CITY OF NOVI CITY COUNCIL
MARCH 2, 2020

SUBJECT: Consideration of tentative approval of the request of Robert B. Aikens & Associates, LLC and Robertson Brothers Homes, for Sakura Novi, JZ19-31, with Zoning Map Amendment 18.732, to rezone property from Office Service (OS-1), Office Service Commercial (OSC), and Light Industrial (I-1) to Town Center-1 (TC-1), subject to a Planned Rezoning Overlay (PRO) Agreement, and corresponding PRO Concept Plan. The property is located north of Grand River Avenue, south of Eleven Mile Road, and east of Town Center Drive in Section 23, and totals approximately 16 acres. The applicant is proposing to develop the property as an Asian-themed mixed-use development.

SITE CONSTRAINTS

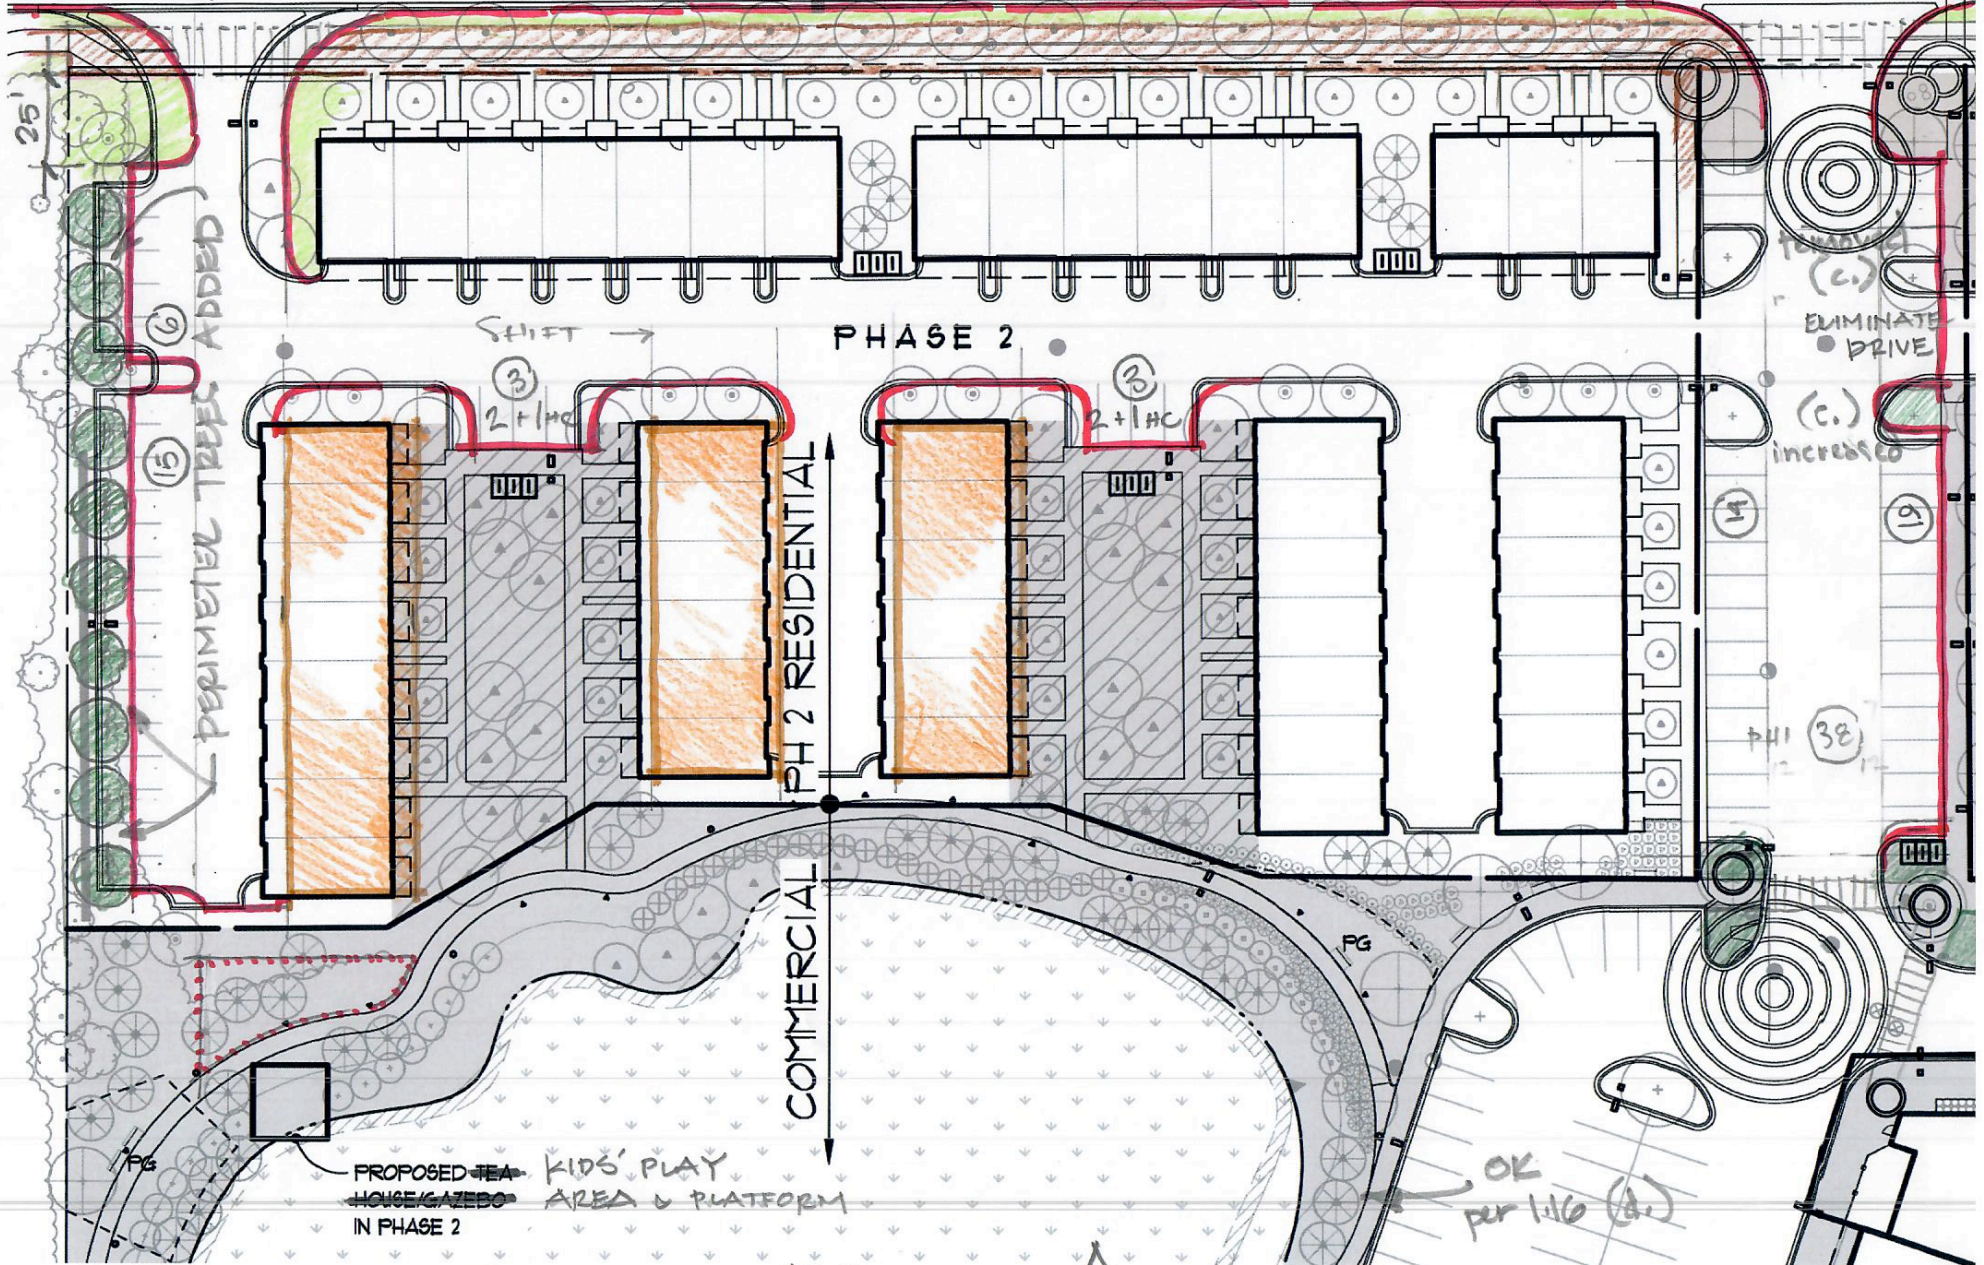
DRIVES TO BE ALIGNED - REQ'D

27 SURFACE STALLS (WAS 28)

UNSUPPORTED DEVIATION (d.)

BERM + LANDSCAPE

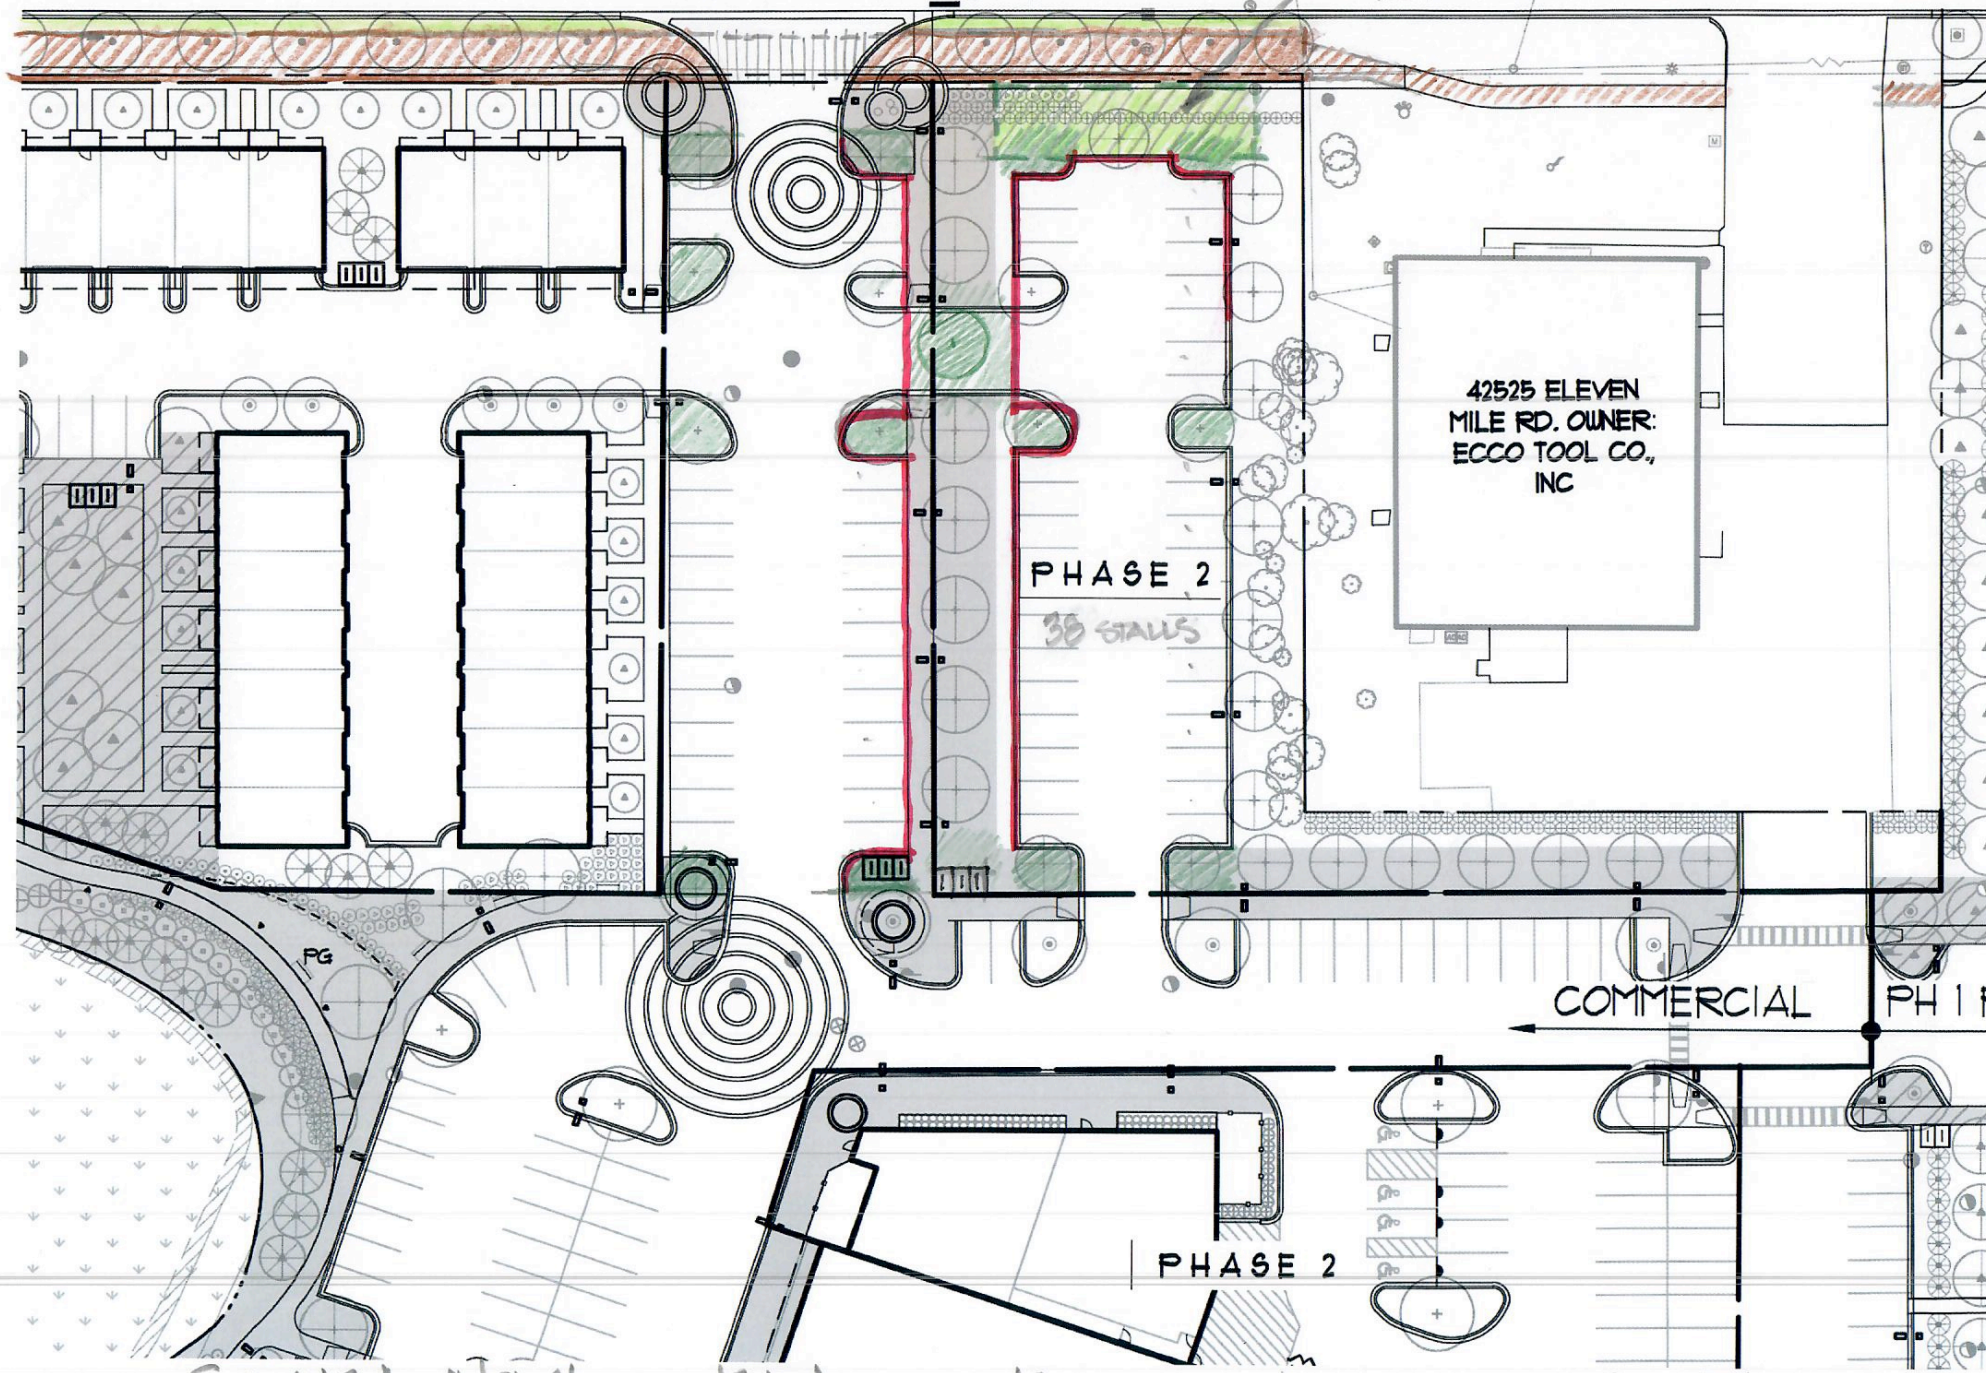
UNSUPPORTED DEVIATION (b.)

**PRELIMINARY
NOT FOR CONSTRUCTION**
P4.3

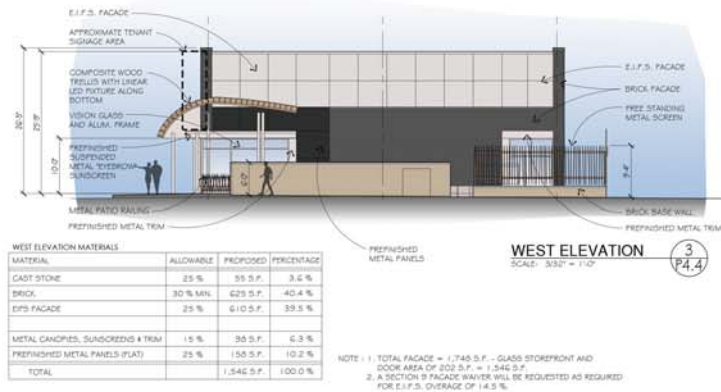
NOTE: 1. TOTAL FACADE = 1,647 S.F. - GLASS STOREFRONT AND DOOR AREA OF 335 S.F. = 1,312 S.F.
2. A SECTION 9 FACADE WAIVER WILL BE REQUESTED AS REQUIRED FOR PREFINISHED METAL PANEL COVERAGE OF 26.1% AND BRICK SHORTAGE OF 3.3 %.

NOTE: 1. TOTAL FACADE = 1,729 S.F. - GLASS STOREFRONT AND DOOR AREA OF 0 S.F. = 1,729 S.F.
2. A SECTION 9 FACADE WAIVER WILL BE REQUESTED AS REQUIRED FOR PREFINISHED METAL PANEL COVERAGE OF 25.7 %.
